S/1 NEWS

OCT-75

INSTRUCTION FOR THE REPLACEMENT OF THE CX-7B POWER SUPPLY BOARD

FIGURE 4-5. POWER SUPPLY BOARD (SHEET 1)

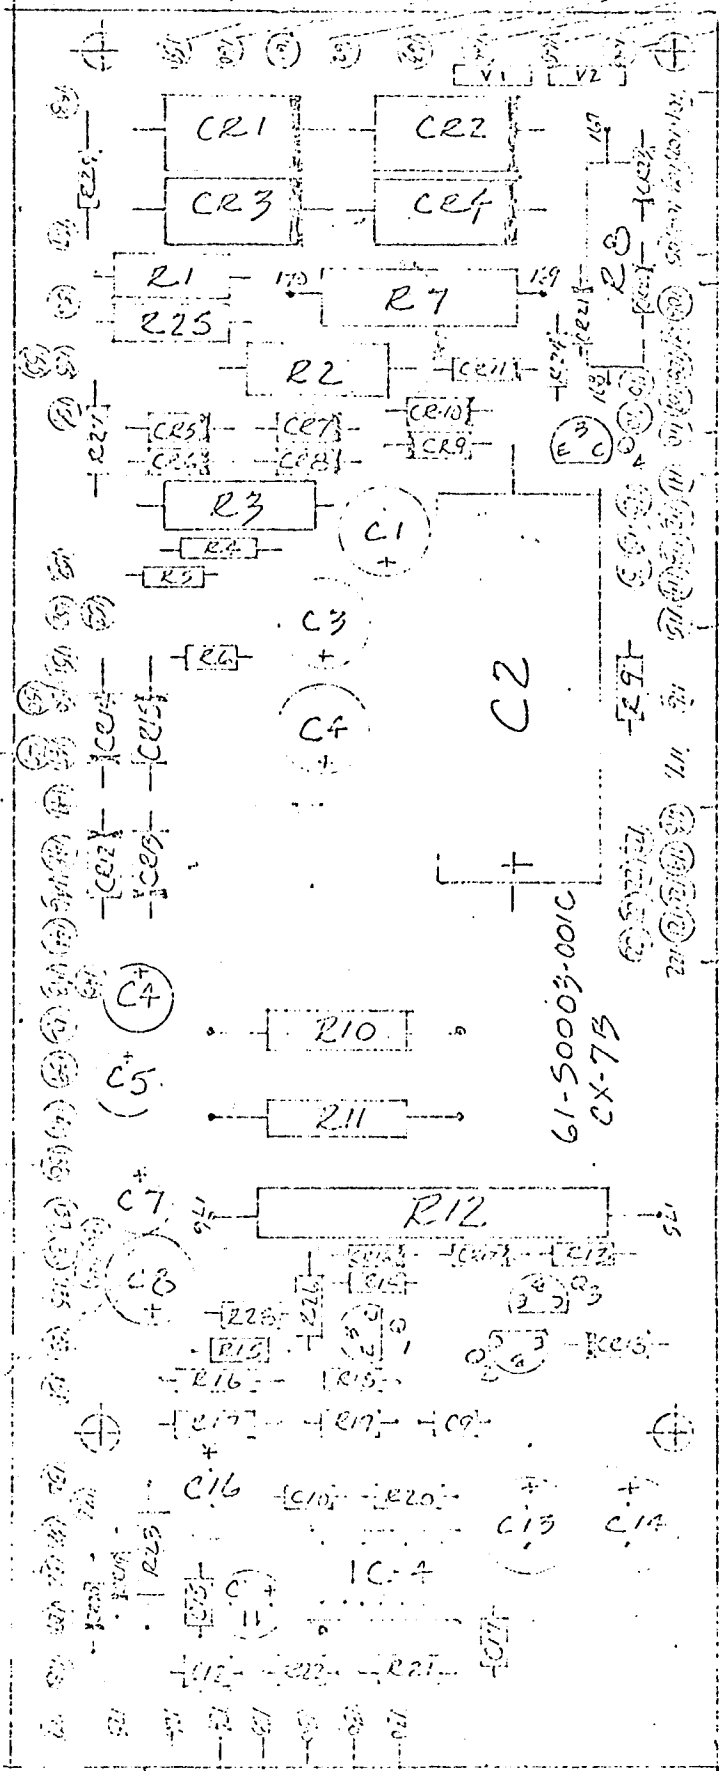
1. Remove the outside dust cover from the radio.
2. Place the radio so that power supply board will be at your upper right (on left end).
3. Remove the four mounting screws holding the board to the standoffs.

4. With care so as not to damage the leads and the push-on "Amp solderless terminals" move the board as required to gain access for the following steps.

5. Located on the radio rear panel, remove Q1 (the tip 29 with the red lead) and replace wire for wire with the provided MC7815. Do not insulate the mounting tab, but use thermal compound provided.

6. As in Step 5, remove Q2 (the tip 30 with the blue lead) and replace pin for pin with the MC7915. Insulate the mounting tab with existing hardware and install in the rear back panel of the chassis with thermal compound provided.

7. As in Step 5, remove Q3 (the tip 29 with the brown lead) and replace pin for pin with the MC7805. Do not insulate the mounting tab, but use thermal compound provided.

8. As in Step 5, remove Q4 (the tip 29 with the orange lead) and replace the leads in the following order:
 - Orange Wire No. 62 to Pin 1 (Base)
 - Wire No. 374 to Pin 2 (Collector)

- Wire No. 63 to Pin 3 (Emitter)
 with the MJE1103 provided. Insulate the mounting tab (collector) with existing hardware and install at lower rear of back chassis panel with thermal compound provided.

9. Wire jumpers on the new board as desired for either 117 or 230 volts. Pins 163, 164, 165 and 166. Circuit boards are furnished wired for 117.

10. Un-solder the transformer primary leads (preferably one at a time) from the old board and connect and solder to the new board (same pins as in Step 9).

11. Carefully disconnect all amp connectors and remaining solder connections and remove old board.
12. Place the new power supply board in position and connect the amp connectors on the new board as shown. USE CAUTION -- the direct interchangeability of the board generates gap pins not used along the rear panel. Do not inadvertently fail to skip unused amp connectors. Carefully solder the high-voltage wiring to Pin 162 and the low voltage transformer secondary to Pins 146 and 153.

FIGURE 4-5. POWER SUPPLY BOARD (INLET SIDE)

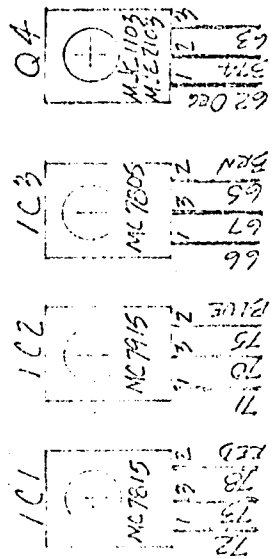
Install jumper wire in place of R65 and R66 12Ω 1/2 Watt resistors and remove Q16 and Q17 and in its place install MPS U05 carefully observing emitter base collector marked on U05 package in place of 2N5183.

Break wire 193 to J1 phone to Pin 1 J1 phone jack.
Connect wire from Pin 1 J1 to power supply board Pin 130.
Route new wire along existing wiring harness.
